**STATE OF MINNESOTA
BEFORE THE PUBLIC UTILITIES COMMISSION**

**In the Matter of
Otter Tail Power Company's
2021 Integrated Resource Plan**

**PUC Docket No.
E017/RP-21-339**

Clean Energy Organizations' Initial Comments

Figure 1. Otter Tail's Planned Carbon-Free Generation System Wide

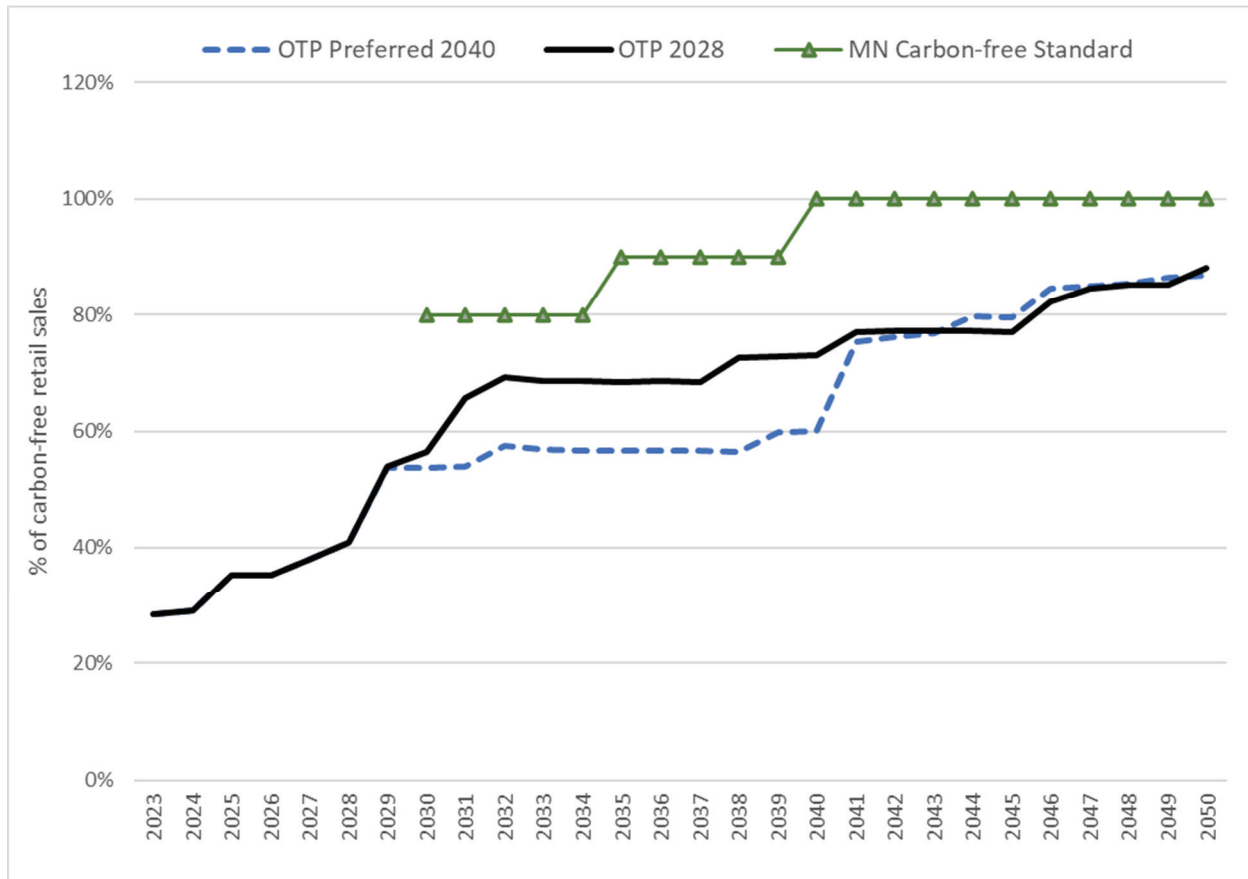
Otter Tail claims in its Supplemental Resource Plan that it will be able to comply entirely with Minnesota's Carbon Free Standard ("CFS") while continuing to rely on its two polluting coal plants and without building any more carbon-free power than it otherwise plans.¹⁴ However, as Figure 1 shows, on a system-wide basis Otter Tail is currently generating or procuring carbon-free generation amounting to only about 28% of its sales. By 2030, its carbon-free generation would amount to only 54-57% of retail sales (depending on whether it withdraws from Coyote in 2040 or 2028) rather than 80%; by 2035 its carbon-free generation would amount to only 57-68% of retail sales rather than 90%; and by 2040 its carbon-free generation would amount to only 60-73% of retail sales rather than 100%.

Otter Tail asserts that it can make up the substantial shortfall in carbon-free generation (while continuing to run its coal plants) solely by relying on renewable energy credits (“RECs”) obtained from the renewable energy it generates or plans to generate for its North and South Dakota customers. While CEOs recognize that the CFS applies only to Minnesota retail sales and allows for the use of RECs for compliance, the law requires the Commission to establish the specific criteria for demonstrating compliance with the CFS. In its implementation of the CFS the Commission must, among other things, take all reasonable actions within its authority to maximize the net benefits of the law to all Minnesota citizens, including by ensuring that statewide air emissions are reduced.¹⁵ The Commission has not yet established CFS implementation criteria,

Accepting CEOs Preferred Plan, in contrast, would not only save customers money but would also avoid potential conflicts with the CFS, since the resulting increase in Otter Tail's percentage of carbon-free generation would unquestionably move it toward compliance with the CFS, and in a way that benefits all Minnesotans, as required. Withdrawing from Coyote in 2028 and Big Stone in 2030 would also substantially reduce statewide greenhouse gas emissions, helping the state achieve its economy-wide decarbonization goals of 50 percent by 2030 and net-zero by 2050.¹⁷

Figure 9. Comparison of Annual CO₂ Emissions

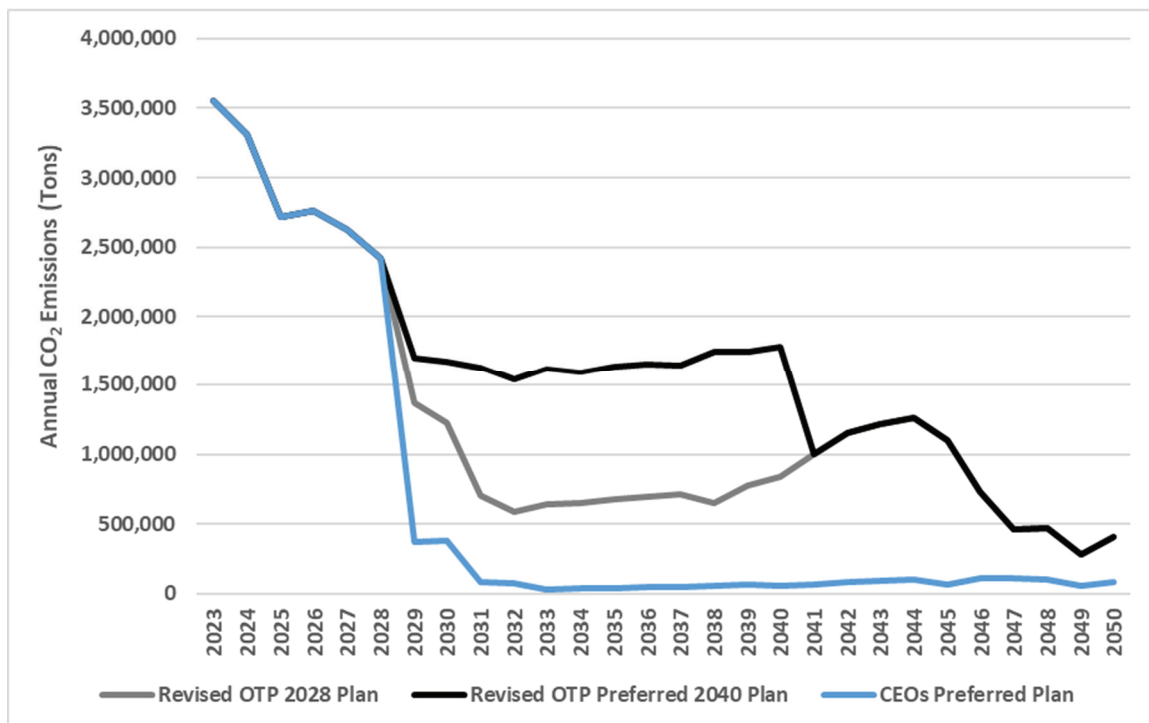
Figure 9, taken from EFG’s report,¹⁷³ compares the annual CO₂ emissions of the three plans through 2050. All three plans deliver emissions reductions between 2023 and 2029. This is partially due to planned new carbon-free resources, but also partially because, consistent with the Commission’s current order regarding carbon regulatory costs, EFG’s modeling includes a mid-range regulatory carbon cost of \$15/ton starting in 2025. This regulatory cost of carbon has the effect of suppressing carbon emissions in all three cases; if this carbon cost is not actually imposed

Large differences between the three plans appear after 2028 (when Otter Tail exits Coyote under the CEOs Preferred Plan and under the OTP 2028 Plan) and especially after 2030 (when Otter Tail exits Big Stone under the CEOs Preferred Plan). Under the Revised OTP Preferred 2040 Plan, carbon emissions largely plateau in the 2030s and show a rise by the end of the decade. Under the Revised OTP 2028 Plan, carbon emissions continue to drop until 2032, though not as steeply as under the CEOs Preferred Plan, and then begin to climb again until the mid-2040s. The CEOs Preferred Plan, by contrast, reduces emissions dramatically in 2029 and again in 2031, and emissions remain very low thereafter. By reducing coal plant emissions to zero by 2030 and dramatically reducing overall CO₂ emissions, CEOs Preferred Plan is in sync with the pathway to U.S. GHG reduction goals charted by the federal government and numerous scientific and energy industry studies.

On a cumulative basis, the CEOs Preferred Plan would result in 25,909,995 fewer tons of CO₂ emissions between 2023 and 2050 compared to the Revised OTP Preferred 2040 Plan (see Table 10). Compared to the Revised OTP 2028 Plan, the CEOs Preferred Plan would result in 15,540,587 fewer tons of CO₂ emissions between 2023 and 2050. The benefits of the CEOs Preferred Plan are particularly stark in the 2030s. In that decade, CEOs plan would reduce emissions by 16,072,722 tons compared to the Revised OTP Preferred 2040 Plan (a reduction of 97%), or by 6,397,487 tons (a reduction of 92%) compared to the OTP 2028 Plan.

Figure 10. Annual Total PM_{2.5} Public Health Impacts of Each of Otter Tail's Coal Plants²⁰³

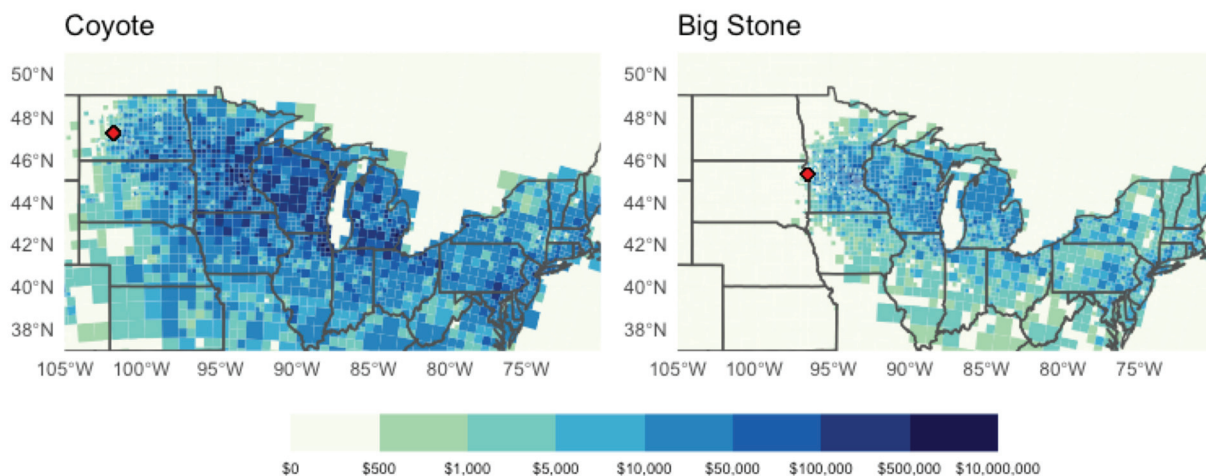
PSE went on to look at the *distribution* of the health impacts associated with the operation of Big Stone and Coyote to see geographically where these health impacts are occurring. PSE's findings revealed the impacts from both plants extend across multiple states, particularly downwind and east of the facilities.²⁰² As shown in Figure 10 below, it is clear that although neither coal plant is located in Minnesota, Minnesotans are unquestionably bearing the adverse health consequences of the continued operation of these plants.
